ADDENDUM TO THE CONTRACT

Downtown Seawalk – Miner's Cove to Franklin Dock
Contract No. E13-288

ADDENDUM NO.: **ONE**

DATE ADDENDUM ISSUED: **July 26, 2013**

A-201
Sheet 46 of 78

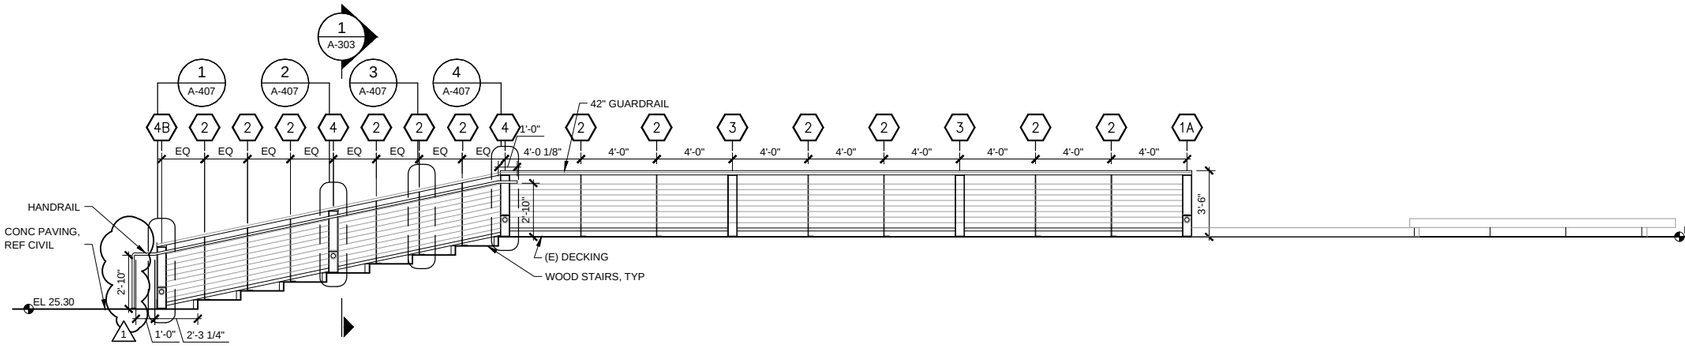
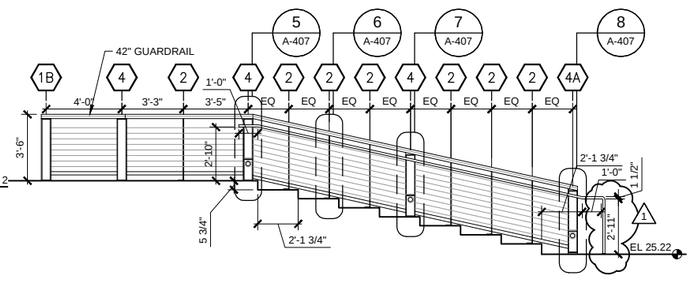
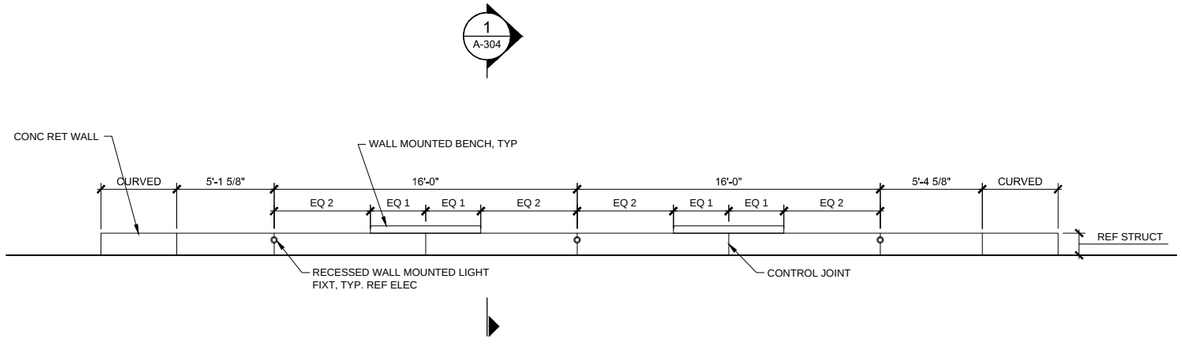
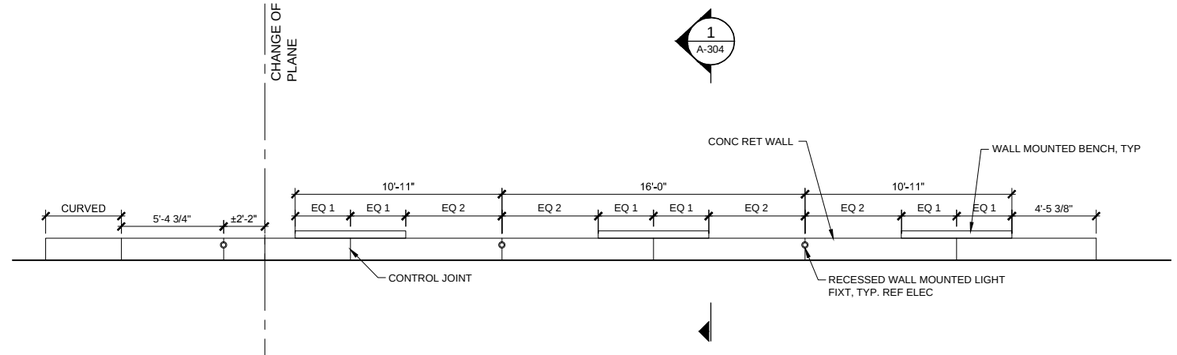
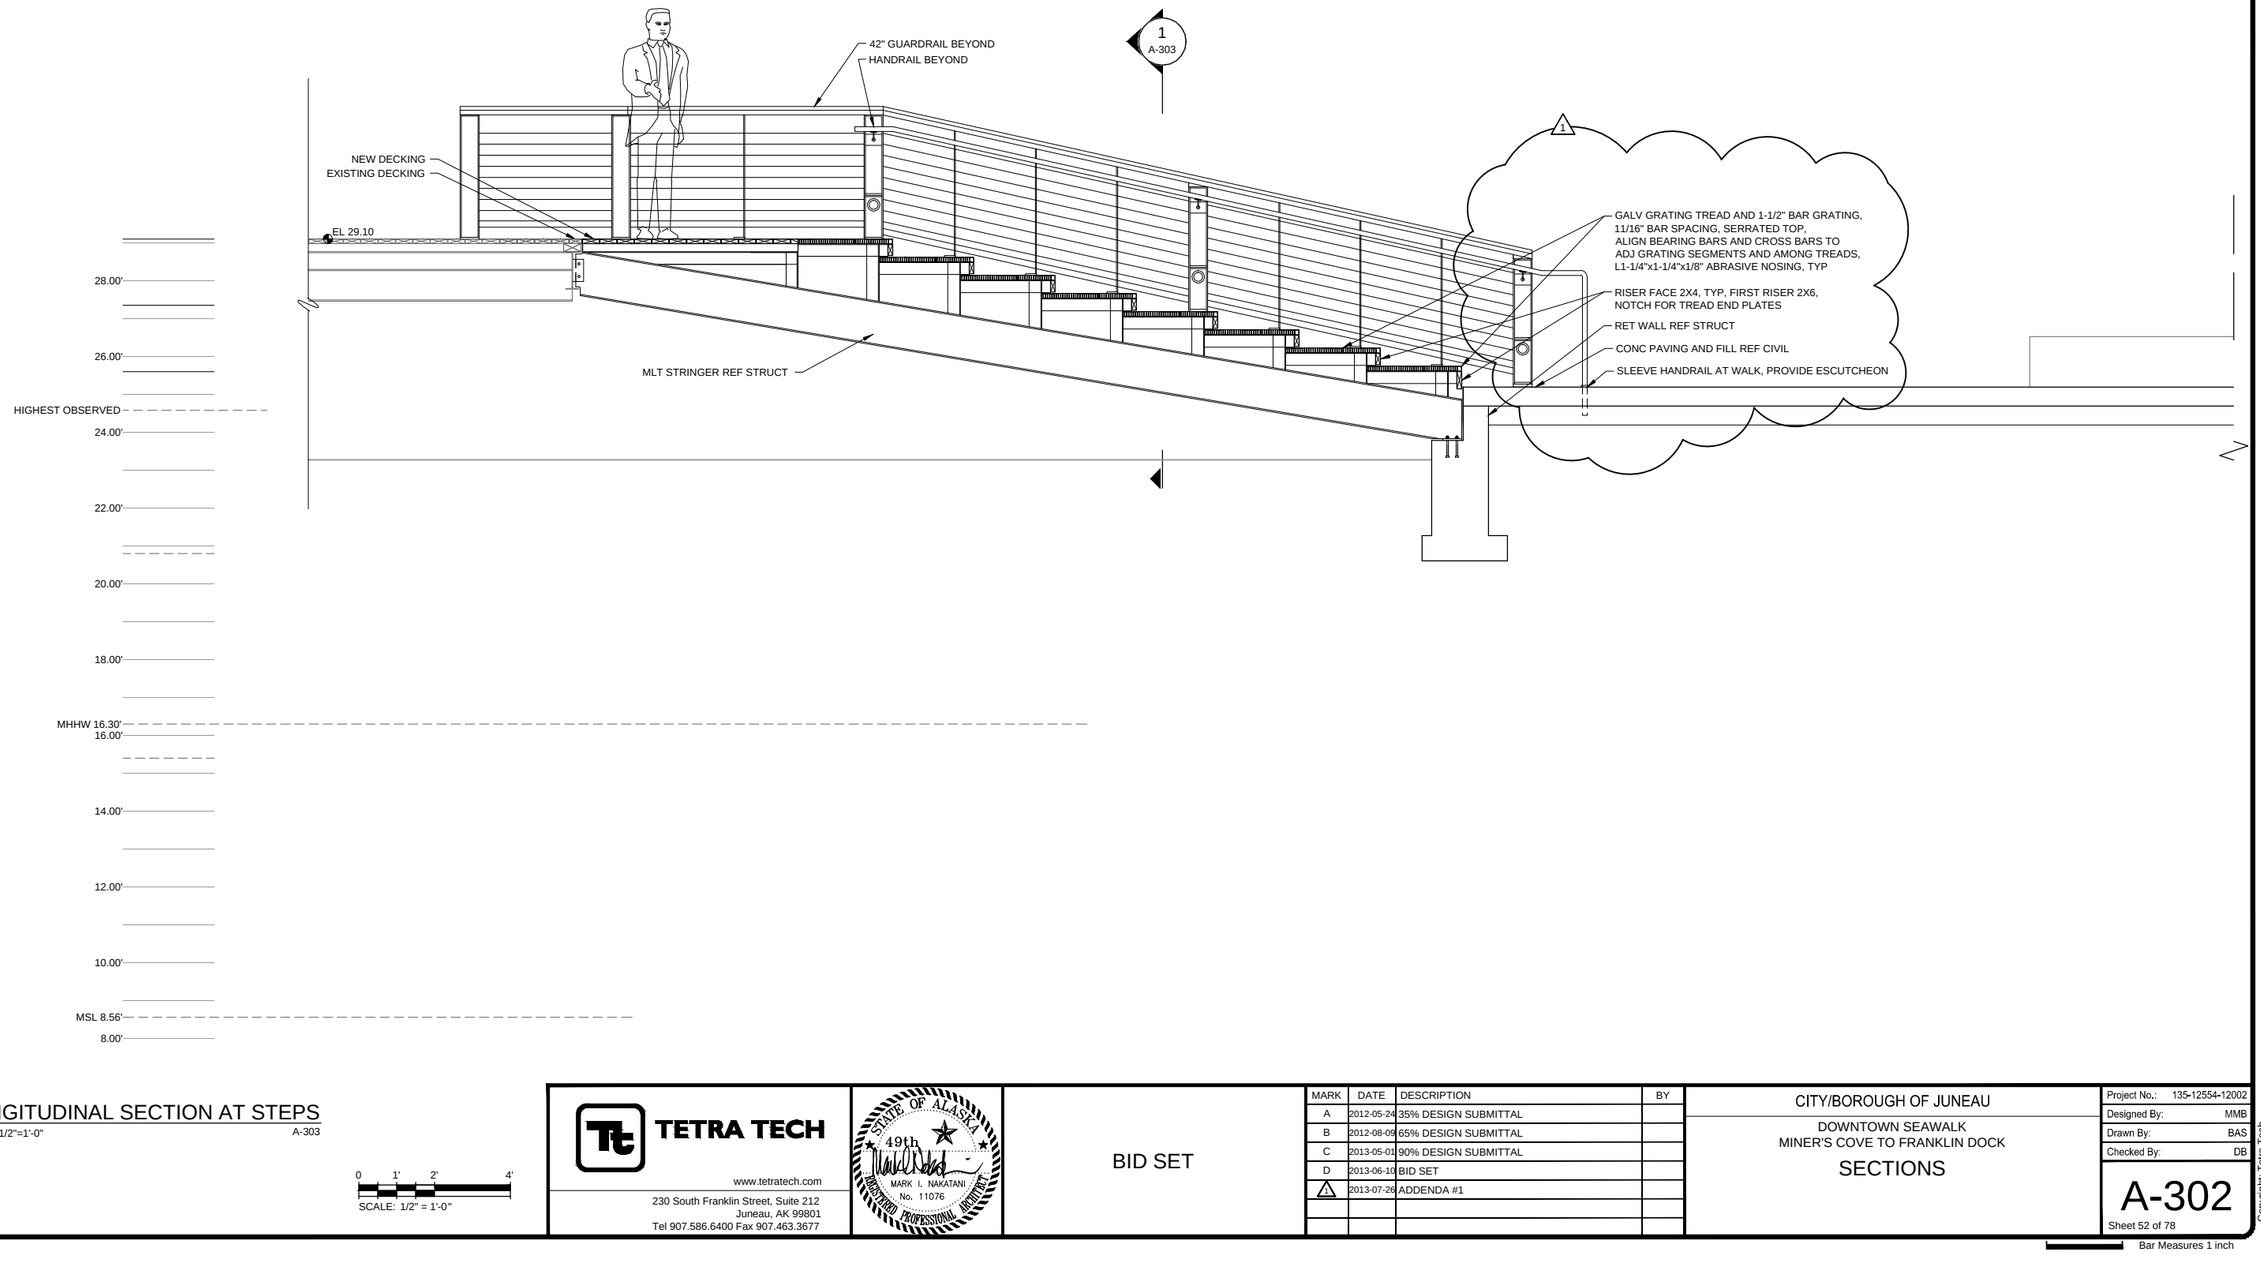
Item No. 9 Sheet A-201 Site Improvement Elevations. ***Delete*** and ***replace*** with the attached sheet, labeled Addendum 1.

A-302
Sheet 52 of 78

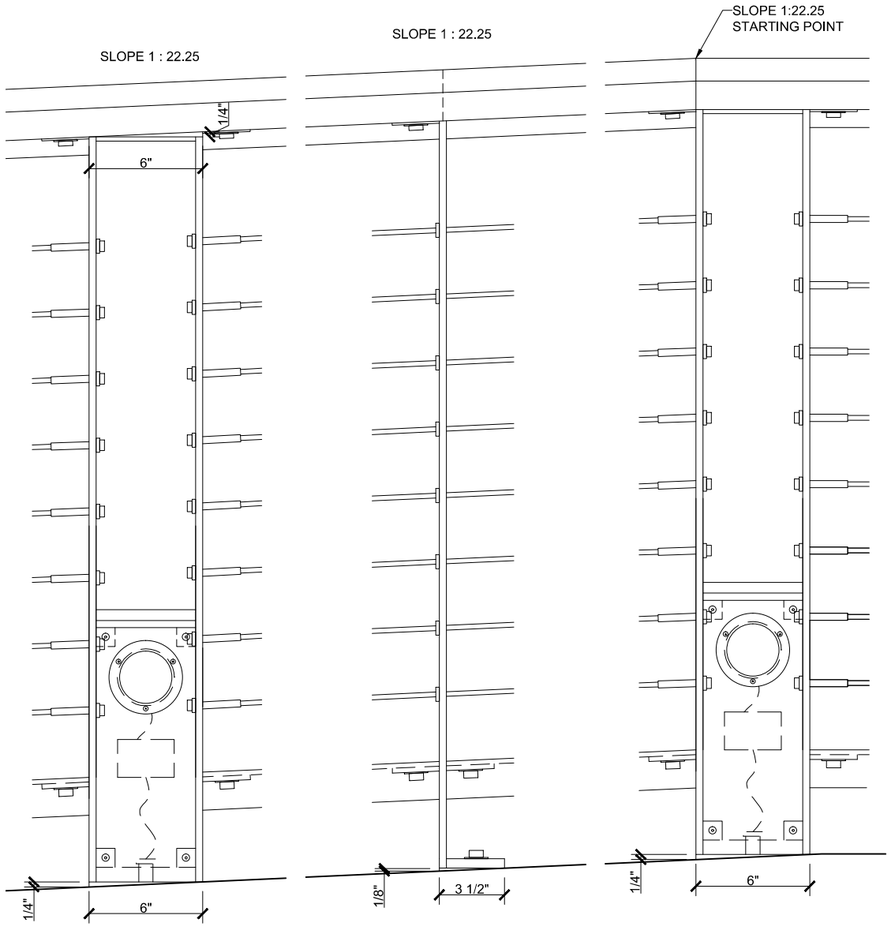
Item No. 10 Sheet A-302 – Sections. ***Delete*** and ***replace*** with the attached Sheet labeled Addendum No. 1.

A-408
Sheet 66 of 78

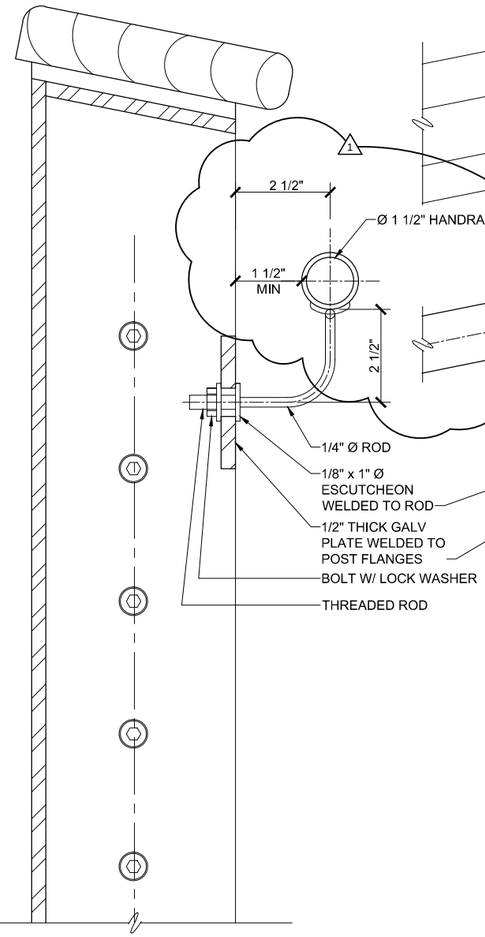
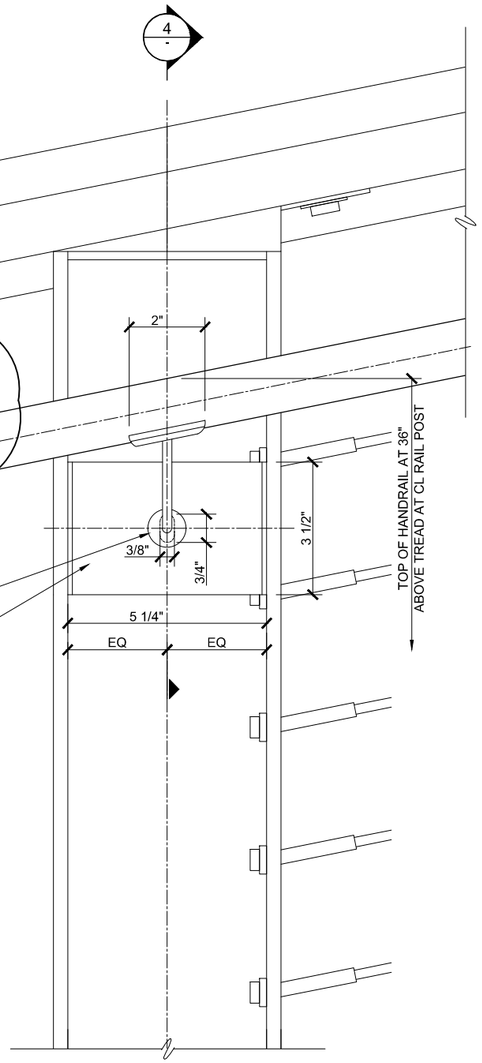
Item No. 13 Sheet A-408 - Railing Details. ***Delete*** and ***replace*** with the attached Sheet labeled Addendum No. 1.

S-601
Sheet 31 of 78

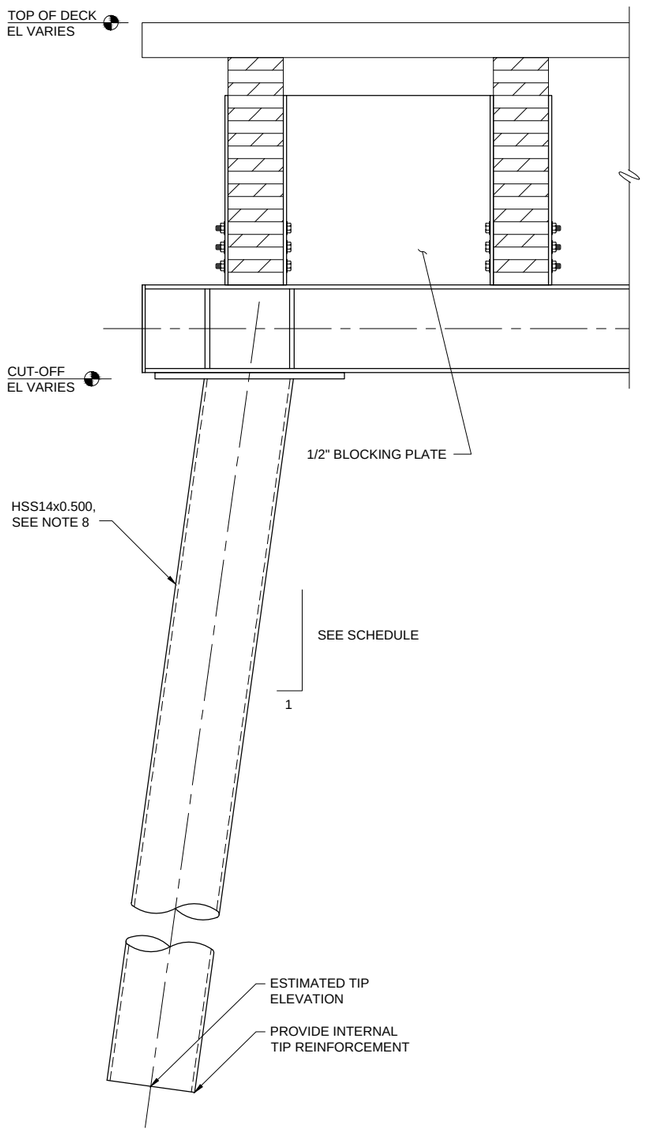
Item No. 14 Sheet A-601 – Pile Schedule. ***Delete*** and ***replace*** with the attached Sheet labeled Addendum No. 1.
